TECHNICAL SERVICE BULLETIN

TSB#: 16-014

DO NOT MOVE THE KITCHEN SLIDE UNTIL CABINET MOUNTING SCREWS ARE REPLACED

2016 Eagle Travel Trailer

FIG 3

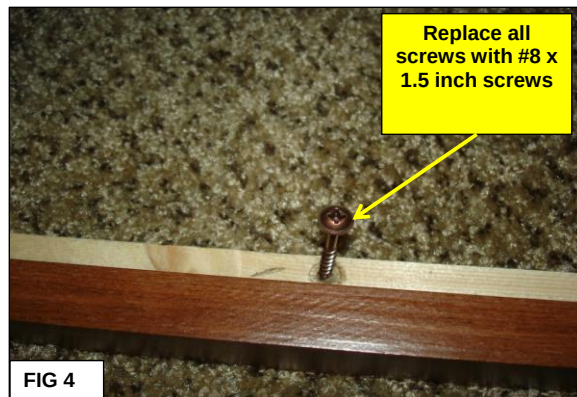
- 2 Fig 3:** Remove **ALL** the screws immediately inside the cabinet door that attach the cabinet frame to the slideout floor. There will be at least 2, possibly more.
Fig 4: Replace with new #8 x 1.5 inches long washer head, wood screws.
